Re: Planning Objection Poynton Spillway Proposal Reference 23/4152M

**FRIENDS OF POYNTON POOL
5 JANUARY 2024
OBJECTIONS TO POYNTON POOL FLOOD MITIGATION PROPOSAL 23/4152M**

Figure 1: Original FN chart (extract Jacobs 2021)

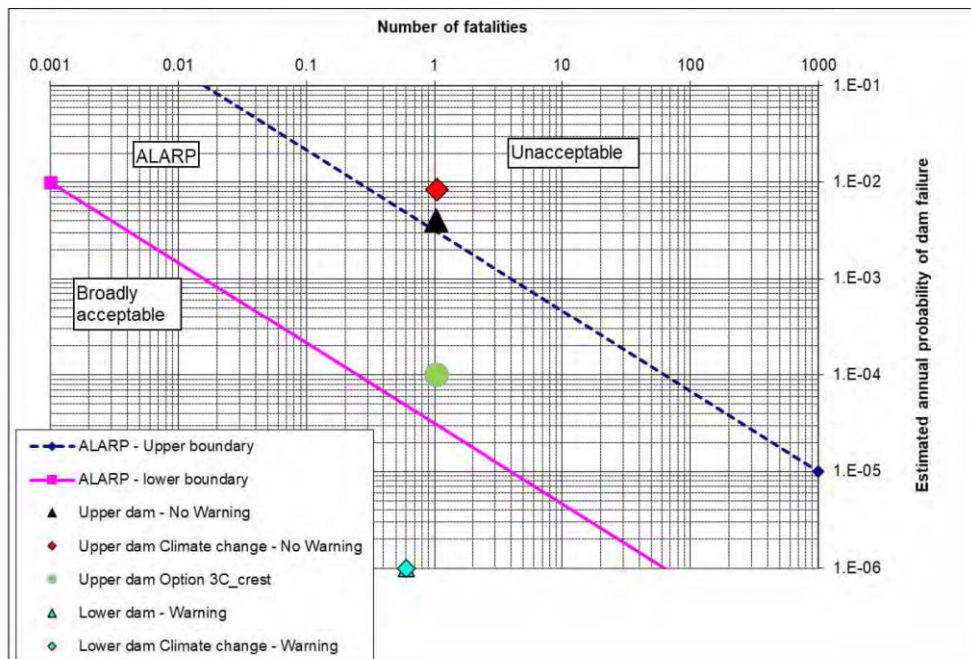
*"The estimated LLOL and index probabilities of dam failure were plotted on an FN chart, see Figure 3.2. This indicates that the current risk for the upper dam lies within the **unacceptable zone**. (Note: quoted figure reference incorrect in Jacobs' report, the FN diagram was actually fig. 4-3. See **figure 1** overleaf).*

This statement was found by FoPP to be seriously in error and that **by Jacobs own measure, the risks were already in the 'ALARP' zone.** FoPP technical experts identified that the risk had been mis-plotted and raised this issue at a meeting with the Council and Jacobs Senior All Reservoirs Panel Engineer in July 2023. By producing a substantially revised *Initial Options Report* (Jacobs 2023) with a new FN diagram, the applicant’s agent has hidden this and other significant errors from the scrutiny of the LPA.

Figure 2: Revised FN chart (extract Jacobs 2023)

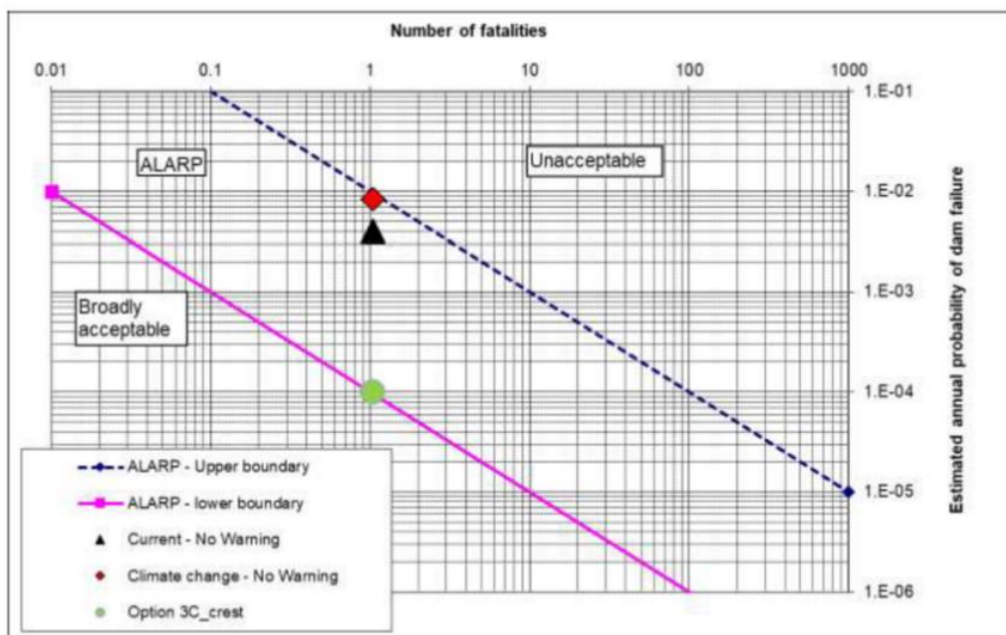
Jacobs Summary Options 2023 which is the main justification for this planning application does not include an updated FN chart, neither is there any reference to the risk being tolerable and that it lies within the ALARP zone.

The Council’s failure to include a revised FN chart with consistent narrative in the planning application options report, as agreed and documented at the meeting in July 2023, means anyone reading the planning application would assume, wrongly, that the flood risk is unacceptable.

FoPP would also like to highlight that the FN chart now excludes the risks for ‘lower dam – with warning’ and ‘lower dam with climate change – with warning’ both of which fall within the acceptable zone, although no explanation is given as to why.

Figure 5: Depth and spread of root systems (extract from Kozlowski 1971)

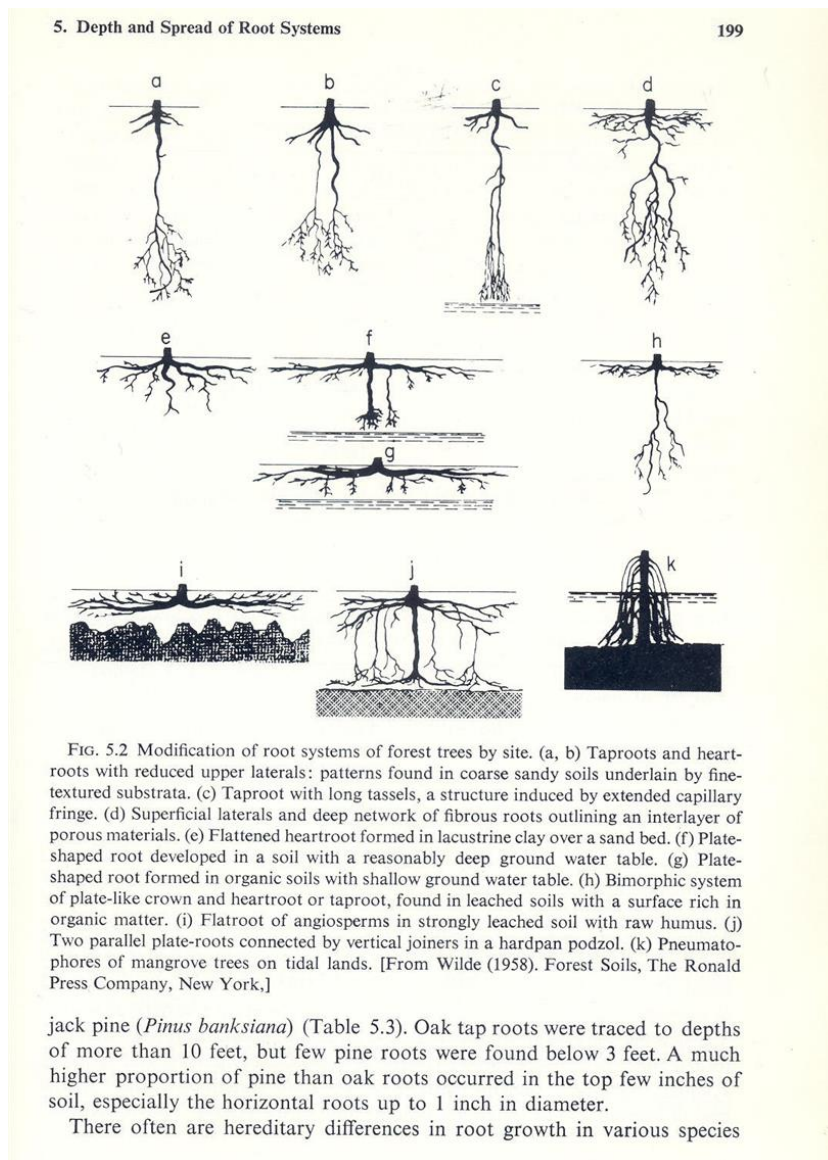
Given the open, permeable nature of the soils identified by Ellison (2023), it is likely that roots of all tree species of all ages on the dam embankment are diffuse throughout the sand and gravel substrate, with a concentration of fine roots in the organic 'A horizon' (topsoil). In these soils, it is likely roots are highly branched, providing a binding of soils. Long roots of a diameter greater than 10-20mm are not likely to be abundant if present at all.

Kozlowski²⁴ reproduces a useful illustration (**figure 5 overleaf**) of the depth and spread of root systems and how, far from having a typical form, root systems are highly variable in their depth and spread. The vascular function of roots in locating and transporting water and mineral elements determines the initial position of the root, following which structural adaptation will occur where there are mechanical loads. Given the tree species and geological conditions of the site, it is highly likely that the trees have varying root architecture similar to examples b, d or e in **Figure 5**, which are forms found growing in permeable ground.

Appendix 2: Option 2A Screw piles with sandy clay loam to both sides

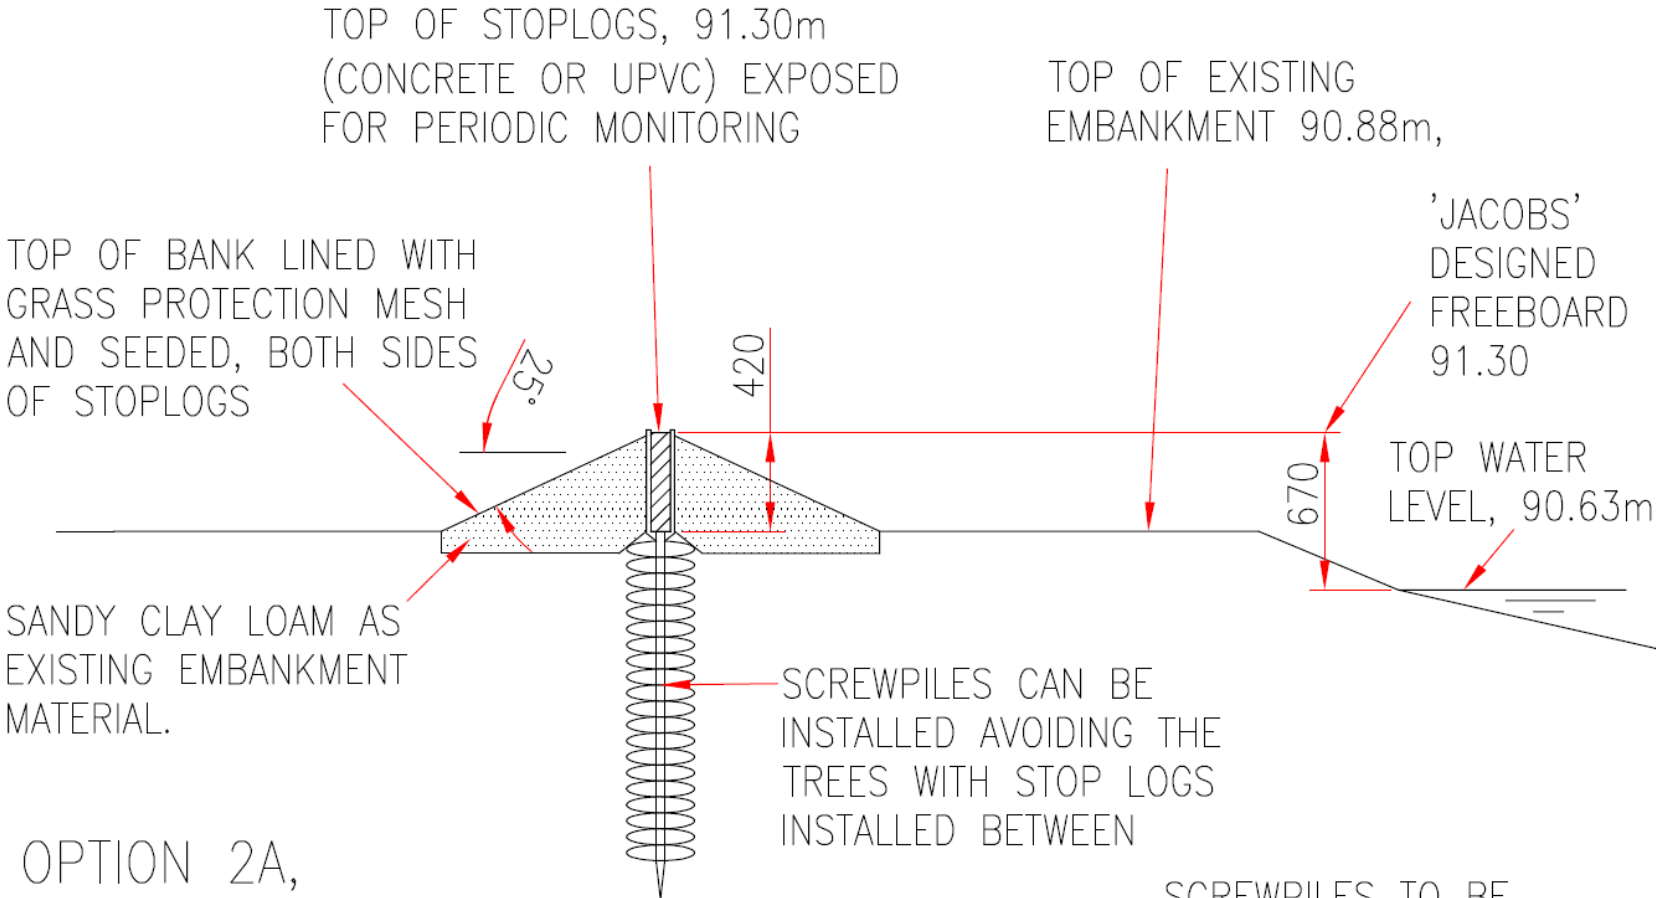
OPTION 2A,
SCREW PILES WITH STOPLOGS
FLOOD RESILIENCE.
(NO DISRUPTION TO TREES, THIS SYSTEM CAN WEAVE
AROUND THE TREES AS NECESSARY).

SCREWPILES TO BE
INSTALLED APPROXIMATELY
1.8m CTRS. (480m) =
268 TOTAL, (ESTIMATE FOR
COSTS)

Appendix 3: Option 3A Sheet pile wall at roadside with sandy clay loam backfill

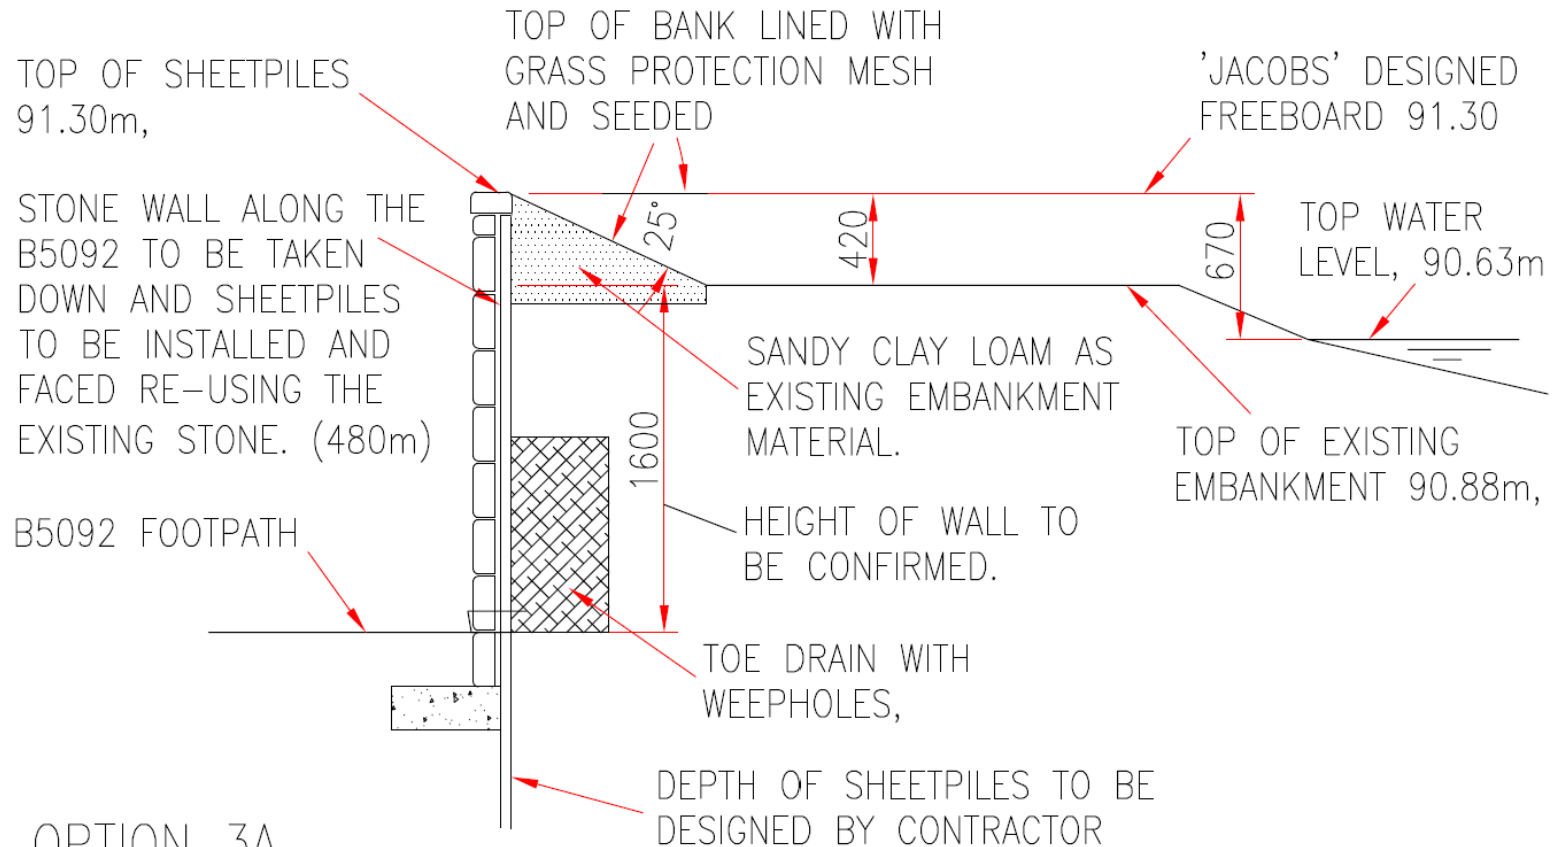
OPTION 3A,
SHEET PILES WITH STONEWALL FACING
FLOOD RESILIENCE.
(NO DISRUPTION TO TREES BEYOND THE INSTALLATION
WORKING ZONE).
